Groundwater Transfer Review Summary Form

Transfer/PA # T- 14898

Ground Water Review Form:

Application: T-14898

Figure 1: Map

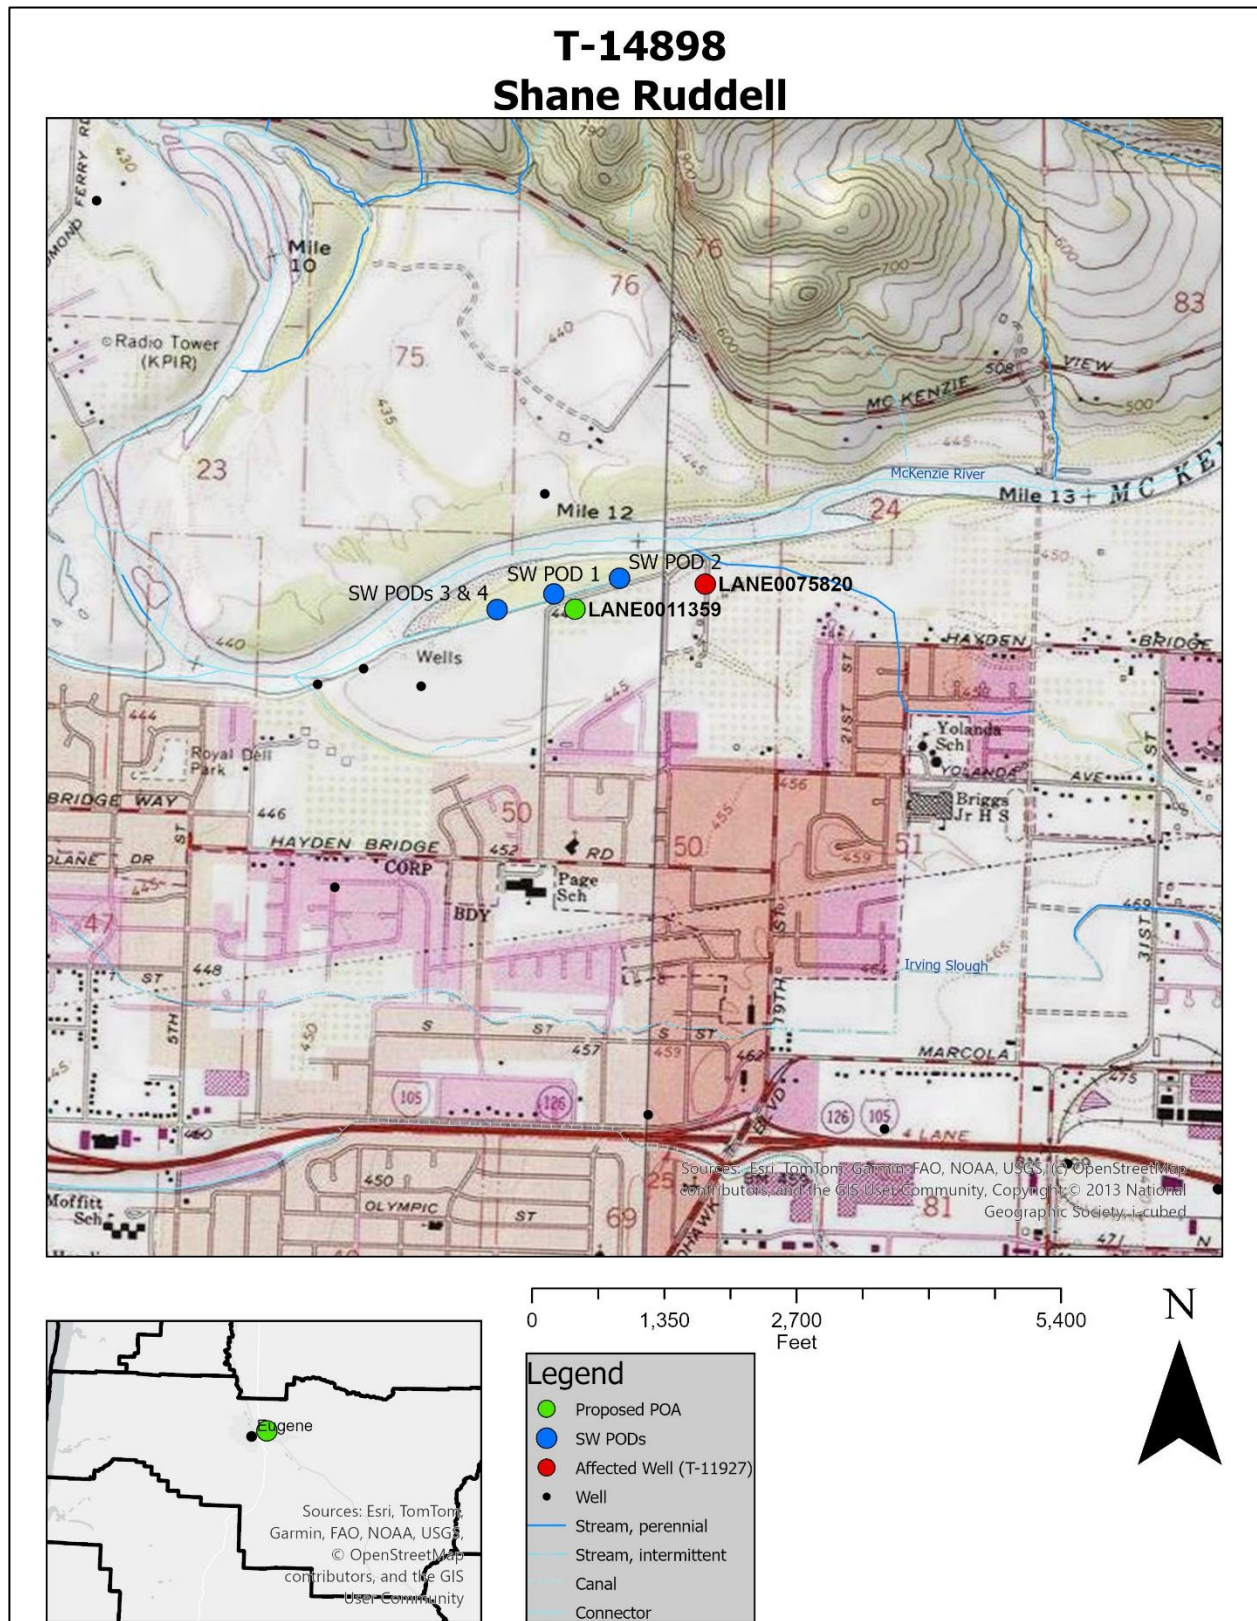
2. Will the proposed POA develop the same aquifer (source) as the existing authorized POA?
☒ Yes ☐ No Comments: The proposed POA is completed in the Upper Sedimentary Unit (USU) and likely the Middle Sedimentary Unit (MSU) of the Willamette Basin as described in Conlon et al. (2005). The proposed POA is 500 ft from the McKenzie River and is hydraulically connected to the McKenzie River.

5. a) Will this proposed change, at its maximum allowed rate of use, likely result in an increase in interference with **another ground water right**?
☒ Yes ☐ No Comments: The proposed POA is approximately 500 ft S from the McKenzie River and is approximately 1355 ft NE from the POA for S-54913 (LANE 75820), which is an irrigation well that is authorized through a previous surface water to groundwater transfer (T-11927). Increased pumping from the proposed POA may cause an increase in interference with LANE 75820.

Figure 2: Streamflow Depletion Estimates and Aquifer Parameters

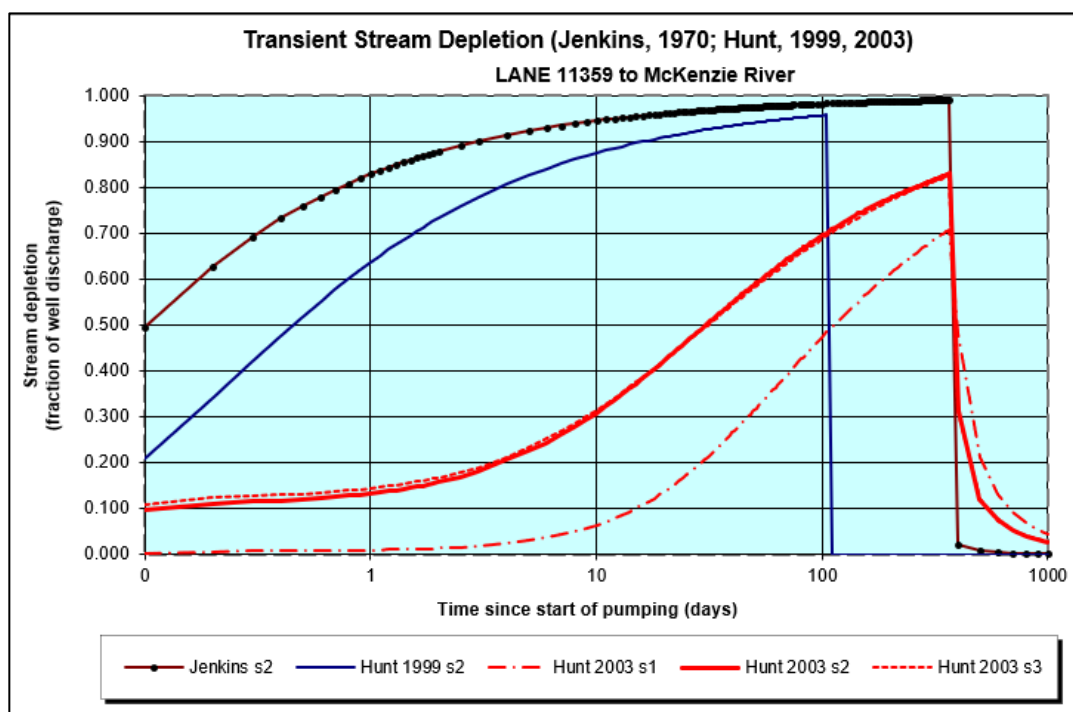
7. For SW-GW transfers, will the proposed change in point of diversion affect the surface water source similarly (as per OAR 690-380-2130) to the authorized point of diversion specified in the water use subject to transfer?
☒ Yes ☐ No Comments: Streamflow depletion estimates were made using Jenkins (1968), Hunt (1999) and Hunt (2003) models. Aquifer parameters like specific yield, aquifer thickness, and hydraulic conductivity were taken from McFarland and Morgan (1996) and Woodward et al (1998). Transmissivity values were taken from nearby pump tests in T17S-R3W, specifically pump tests from LANE 68859, LANE 54485, and LANE 11138. Streamflow depletion estimates using Jenkins (1970) and Hunt (1999) models show high values of streamflow depletion at 94.5% and 87.5% respectively after 10 days of continuous pumping. The Hunt (2003) model shows streamflow depletion of 50% after 31 days of continuous pumping. Based on the hydrogeologic setting, the Hunt (1999) model would be most appropriate and would affect the McKenzie River similarly as defined in OAR 690-380-2130. The streamflow depletion estimates and aquifer parameters are included below as a figure 2.
